24 November 2021

Re: 07_0018-Mod 09 Rasp Mine Modification 9 - Submissions Report

Appendix A – EMM Consulting review of Rasp Mine Water Balance.

Re: J210513 - Rasp Mine water balance

Figure 1: Section view of Blackwood's orebody and proximity to historic 1480 drive.

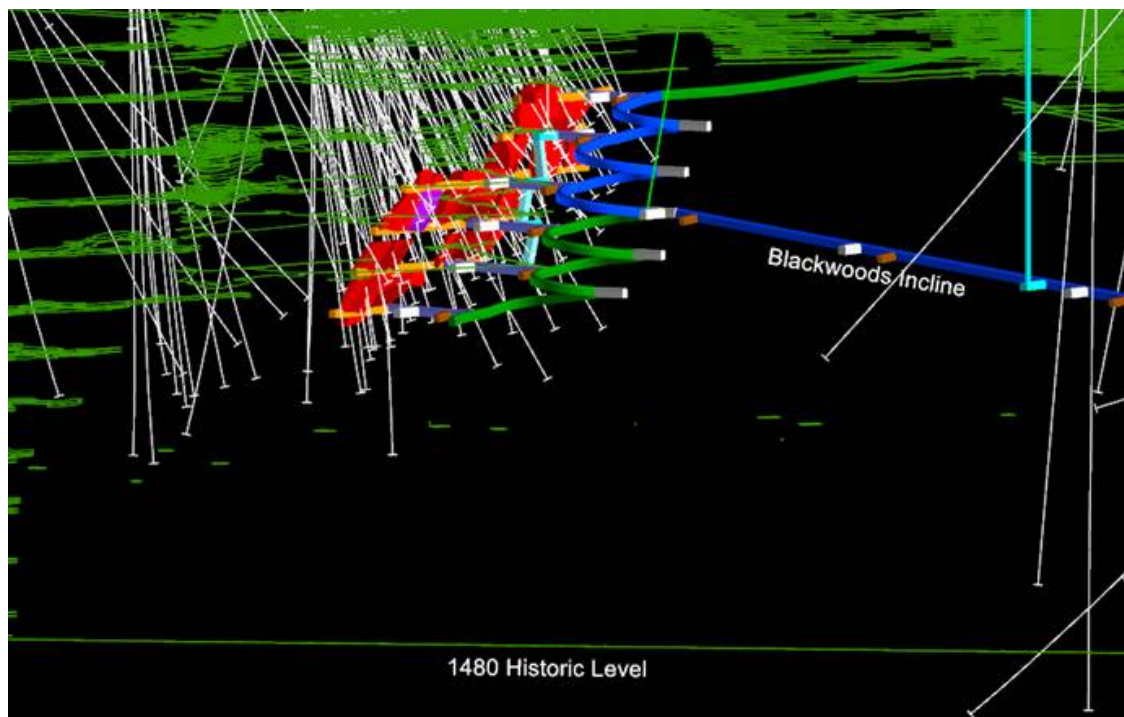
Issue 1: Confirm the predicted maximum annual groundwater take from aquifer interference due to construction and operation of the proposed activities or provide justification that no groundwater is to be intercepted.

The Blackwood's development area is located above the 1480 historical drive. The 1480 historical drive represents 4.1Km and was completed in 1962. The 1480 drive is important because it forms one continuous drive from the North to the South of the lease and is located under and offset (240 to 400m) from the proposed development. The 1480 drive and the proposed development are linked through historic workings and Thompsons shaft to the 1480. The 1480 drive (where all water reports to), is linked to the Shaft 7 whereby it is pumped to surface. Water ingress into the Shaft 7 has been in decline for the last 4 years and less than 2l/s is currently making its way to shaft 7. The evidence of the lack of water within the 1480 drive indicates that the Blackwood's proposed development lies within an overall cone of depression and is dewatered.

Figure 4.2 Underground dewatering

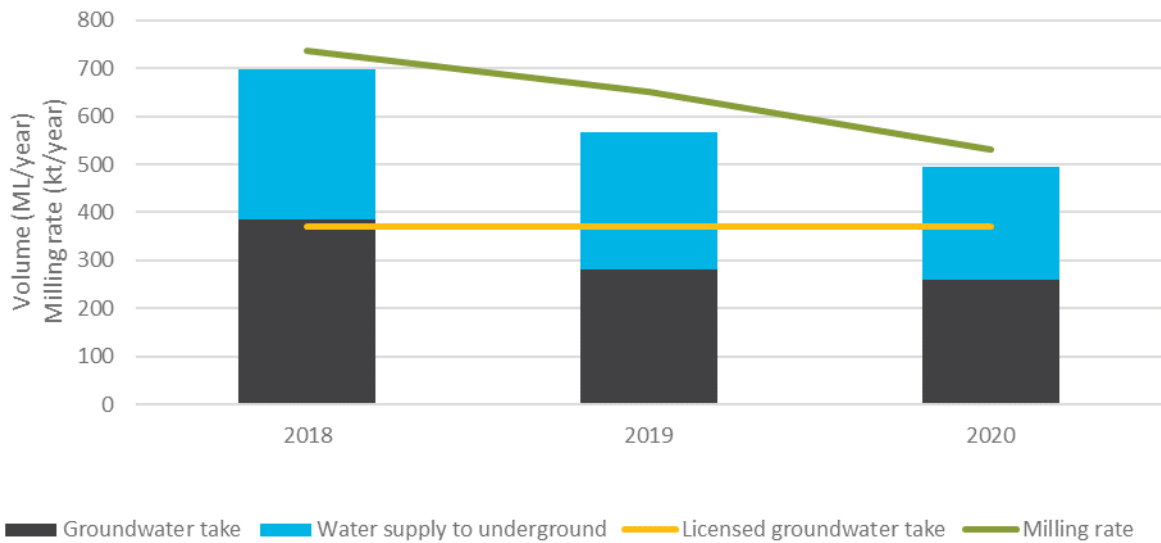
Issue 3: Demonstrate the water take can be accounted for within existing water entitlements held for the project in consideration of all water take at the site. If any additional entitlement is required, an assessment of the ability to acquire this entitlement is requested.

The groundwater take has been trending down over the period of record analysed (2018-2021) (Figure 4.2), with volumes of water supply to underground workings and groundwater interception both reducing in proportion to the mining rate. Approximately 0.45 ML of water is supplied to the underground workings per 1 kt of ore extracted, and approximately 0.5 ML of groundwater is intercepted (Figure 4.3).

Figure 4.5 Recorded dewatering rates

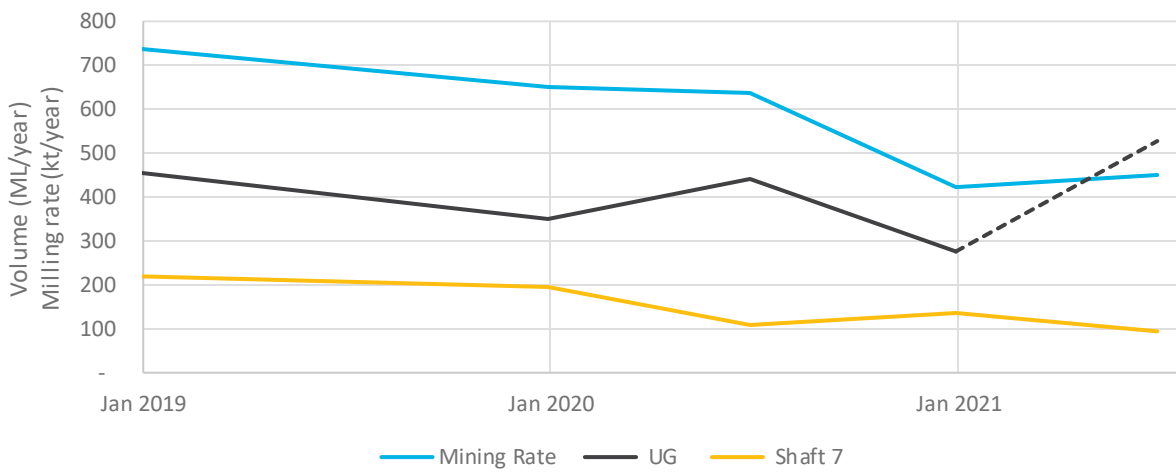
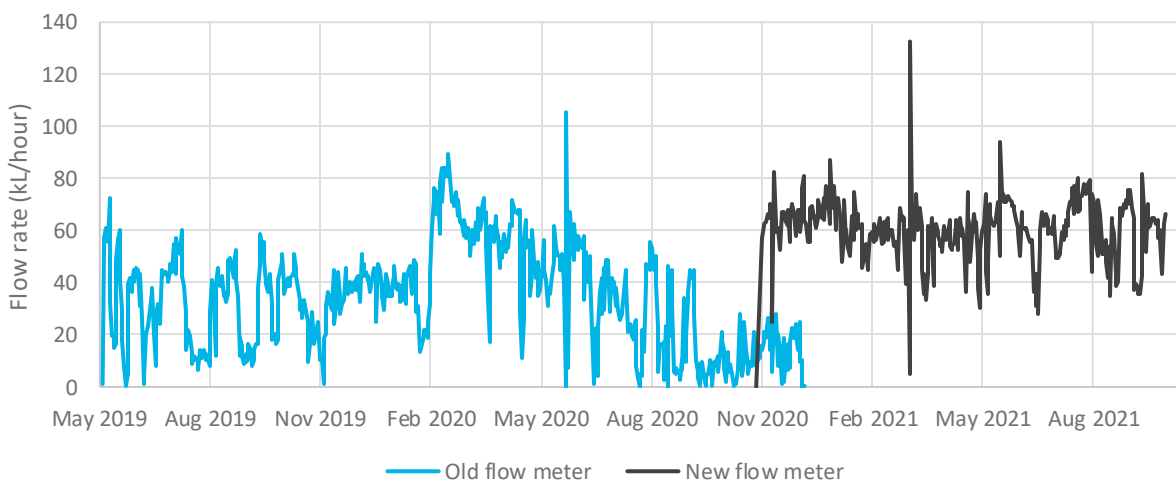
As shown in Figure 4.2 and Figure 4.3, the mine dewatering rate is proportional to the mining rate. Over the assessed period the mining rate has decreased, with a proportional reduction to the rate of water supply to the underground workings (Figure 4.4). However, in the first half of 2021 flow records for dewatering via one of the two dewatering lines ('underground' dewatering) showed an unexpected flow rate increase (Figure 4.5). Flow record spreadsheets include notes which show that the flow meter was replaced at the end of 2020, and the new meter recorded higher flow rates from the time of installation (Figure 4.6).

The observed relationship between mining rate and dewatering over the period 2018-2020, the comparison of metering data for old and new meters, and the lack of S22 pond overflow during 2021 align with the proposition that the new flow meter for the underground dewatering was over-recording flow in 2021, and for this reason the 2021 underground dewatering and groundwater take data were not presented in section 4.2.

It would be reasonable to assume from the available data that and pre-2021 trends present in Figure 4.6 that the total dewatering for 2021 will be approximately 400 ML, and that the groundwater inflow component will be approximately 200 ML.
